Sydney Gateway Road Project

Environmental Impact Statement / Preliminary Draft Major Development Plan

18 Dec 2019

BIKEast Incorporated

Figure 4-8 Existing and proposed cycle routes within the study area

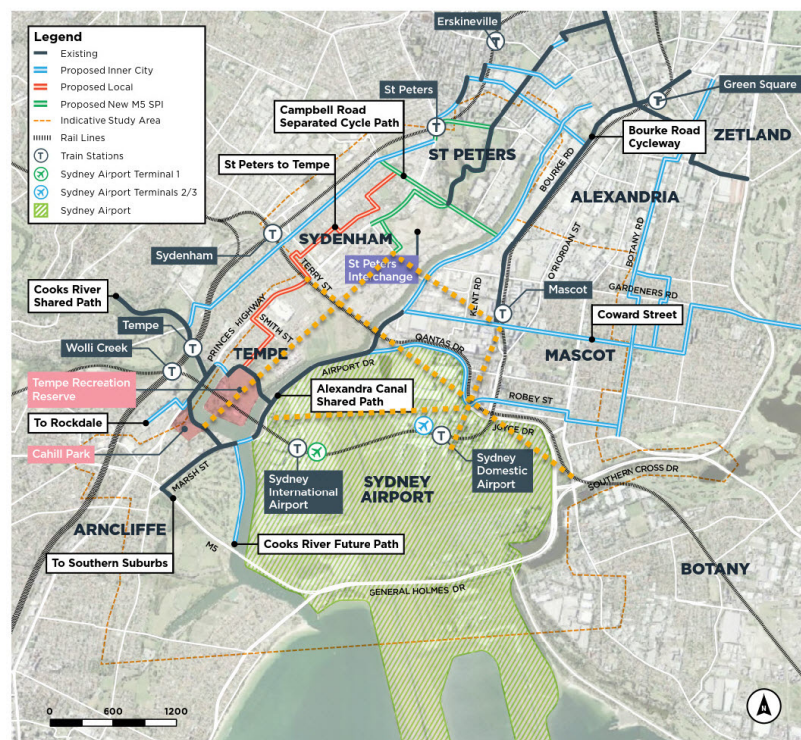
We have outlined 4 specific missing links in the active travel network that relate to the Sydney Gateway project space. These are still missing from the EIS.

1. A connection from St Peters Interchange to the Alexandra Canal cycleway
2. A direct, crossing of the Cooks River from the South towards the CBD
3. Direct connections from the Alexandra Canal cycleway to T2, T3 and beyond, to the Bayside Council network
4. A direct connection between Coward St and Sydenham station (and future Metro)

See yellow dotted lines below.

Diagram 2: South East Sydney Light Rail's King St / Church St detour was on-road (rather than a protected path), 68m longer, with a much steeper gradient and multiple busy intersections.

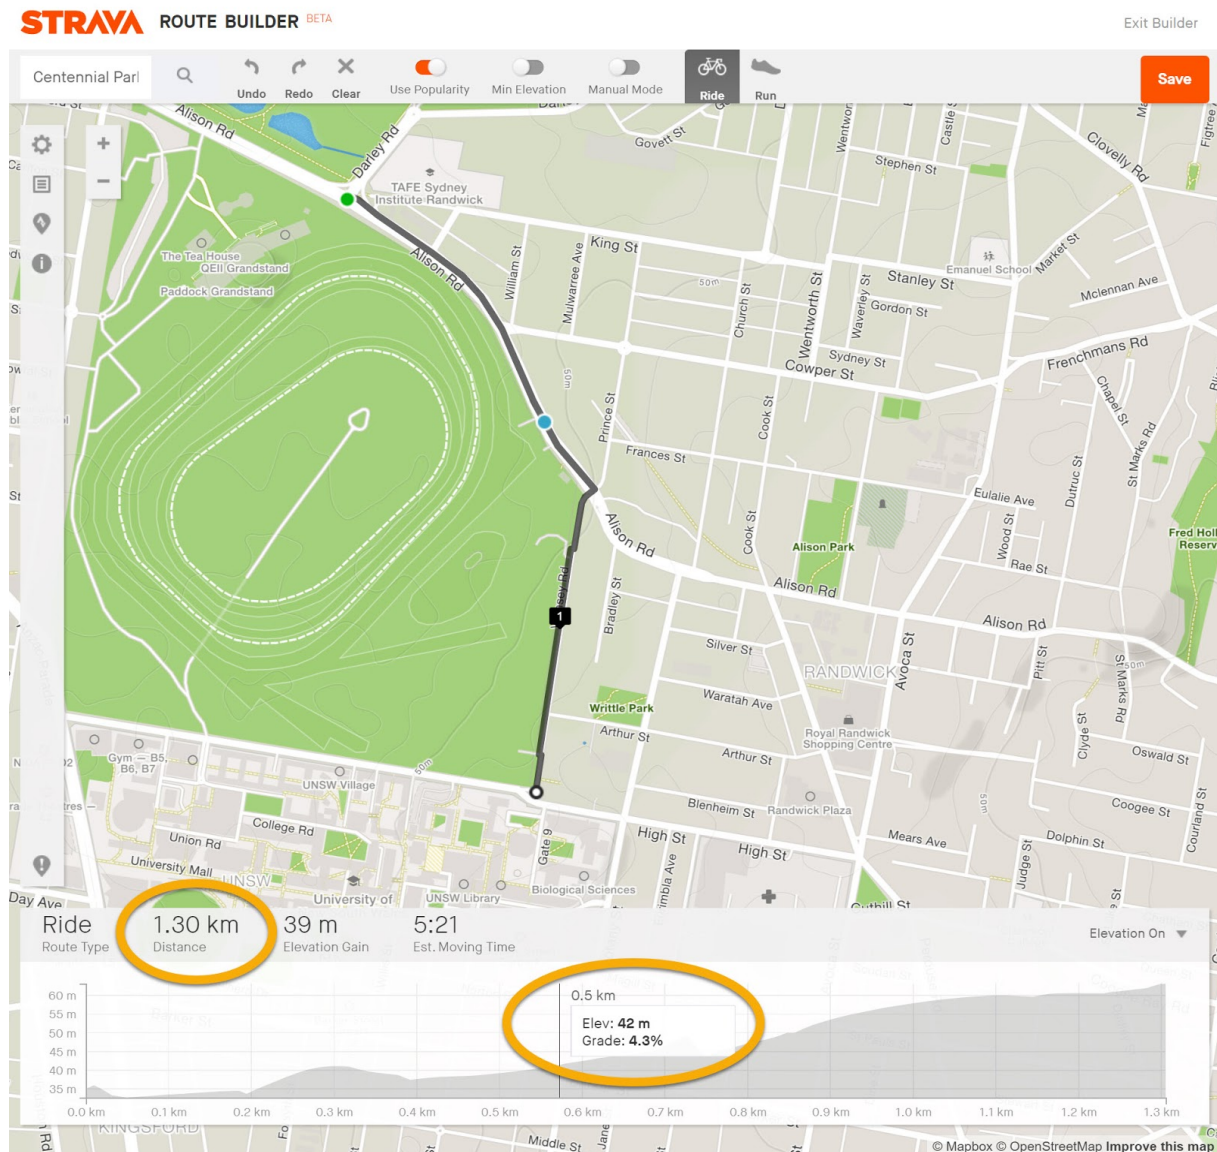
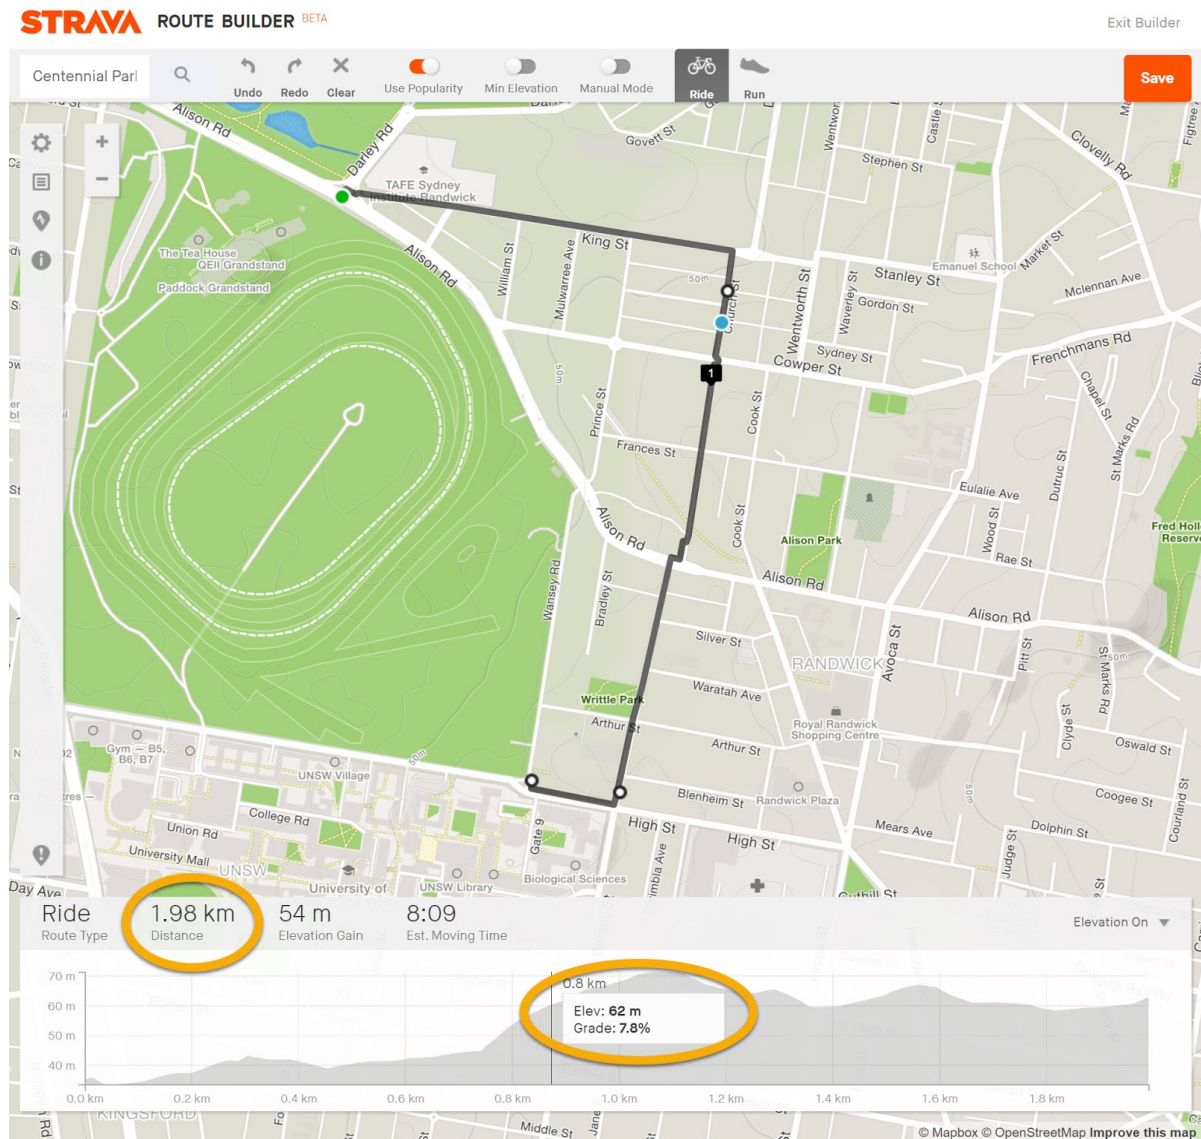
From other transport projects in Sydney (eg. Sydney Light Rail - see Diagram 1 & 2 on the next page, Westconnex Rozelle Interchange), it has been observed that contractors are not willing to provide alternative routes that are convenient and consistent in travel time and distance with existing routes. These oversights have placed heavy and hazardous impact on vulnerable path users such as those with mobility and accessibility requirements, as well as inexperienced and less confident bicycle riders.

BIKEast community members reported that their families did not cycle during construction due to fear of injury.

The conditions of consent must be phrased to provide specific commitment that “walking and cycling access routes during construction must be safe, direct, convenient and consistent in travel time and distance with the existing routes”.

Direct replacement route for existing cycleway

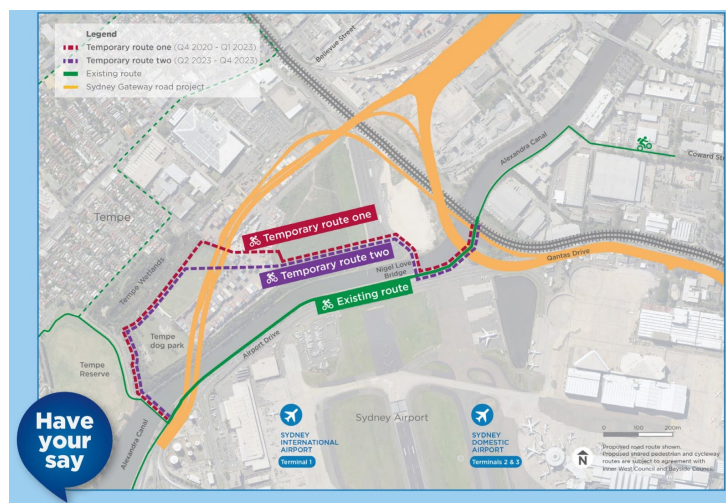
It is unfortunate that the existing cycleway facility must be removed, however, **we thank the Sydney Gateway project for listening to the early feedback from stakeholders such as local councils and**

Bicycle NSW, and providing a replacement that is as direct as possible, alongside the canal. This will support and facilitate easy travel for people currently regularly using the existing route.

We understand that the connection around the rail bridge near Coward St is quite low and will require management for flooding issues, including a pump. **We urge that this facility be designed well to include adequate maintenance and ensure safe community access all year round, including when the canal water level is high.**

We understand the Alternative route marked on the map is not being proposed, as it was a previous proposal, however, we have identified this connection as a missing active travel network connection - that we have outlined in more detail later.

Figure 5.19

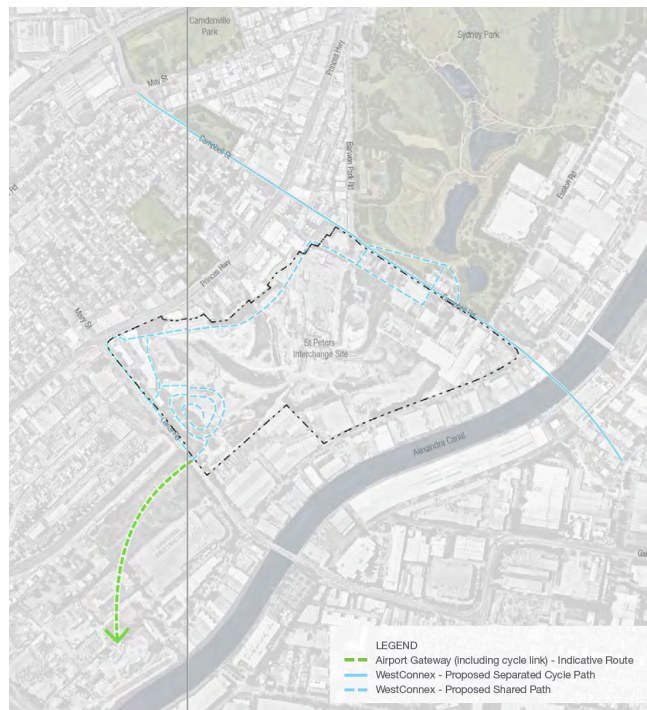
The active travel connections outlined in the [Westconnex New M5 - B51 - Pedestrian & Cycle Implementation Strategy](#) are currently lacking, and the concept design does not provide any additional or alternative connections to the Westconnex New M5 infrastructure and surrounding destinations.

Figure 59: Growing Sydney's bicycle network (visionary)

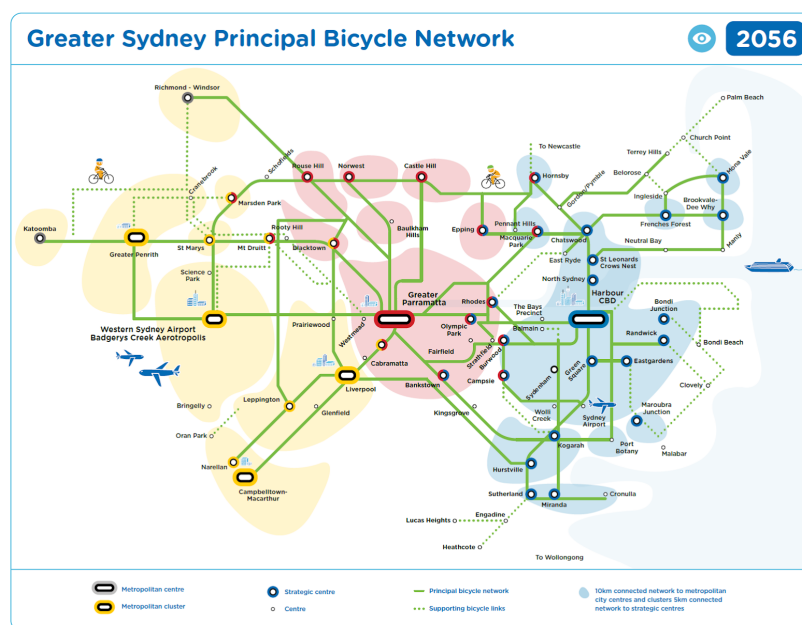
The Greater Sydney Principal Bicycle Network clearly states bicycle connections between Sydney Airport, Sydenham (Metro coming soon) and Wolli Creek.
